**From:** Vicki Harding  
**Sent:** 10 January 2025 22:19  
**To:** Henry Yeung; Planning  
**Subject:** 31 Willoughby Road 2024/5203/P  
**Attachments:** 31 Willoughby Rd H^0HS objection 2024.5203.P.pdf

**Planning Ref:** 2024/5203/P  
**Address:** 31 Willoughby Road London NW3  
**Case Officer:** Henry Yeung  
**Date:** 8<sup>th</sup> January 2025

### Camden Draft Local Plan Map 10: Areas of Historical Flooding in Camden and Local Flood Risk Zones

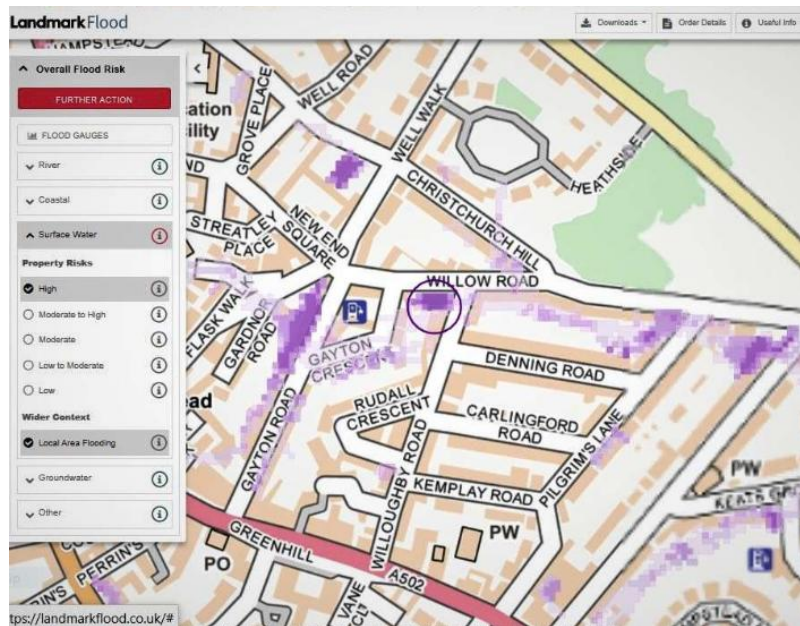
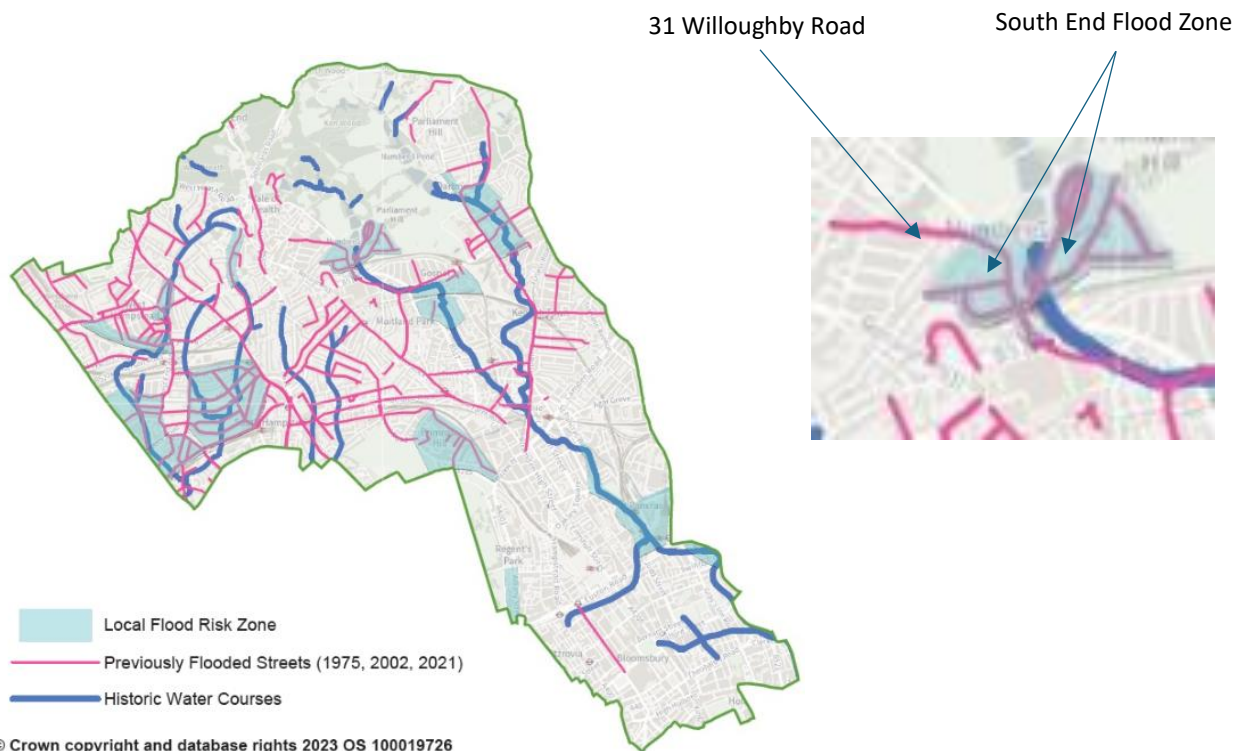
‘Areas at risk of flooding’ in the NPPF are described as included all flood zones, including Flood Zones 1 which has critical drainage problems and which has been notified to the local planning authority by the Environment Agency, as stated in the Technical Guidance to the NPPF: Flood Risk March 2012) where ‘flood risk’ is defined as **‘risk from all sources of flooding - including from rivers and the sea, directly from rainfall on the ground surface and rising groundwater, overwhelmed sewers and drainage systems, etc’** and in the Planning Practice Guidance from March 2014 as (para 4.1.6) ‘the combination of the probability and potential consequences of flooding. Areas at risk of flooding are those **at risk from any source, now or in the future.**’ These can be seen in the following maps:

'Elsewhere' does not imply restricting any risk to merely the neighbouring buildings. This wording was already present in the NPPFs of December 2023 (paras 165 & 170b); September 2023 (paras 159 & 165), and others going back to 2012, therefore they would have applied to planning applications 2016/7146/P and 2020/0927/P as well. We have noted that through all the BIA up-dates, Campbell Reith themselves keep maintaining that 'It is accepted that the extent of impermeable areas is not changing and that, therefore, the risk of flooding at the site and surrounding areas is not altered'. We disagree with this statement (though Campbell Reith did acknowledge 'However, neighbours have submitted a plan showing a different surface water flood risk categorisation.') Risk of flooding is usually and mainly via surface flooding, however there can be other factors in play. There are two geological aspects that should have a bearing on flooding for this application and give us concern:
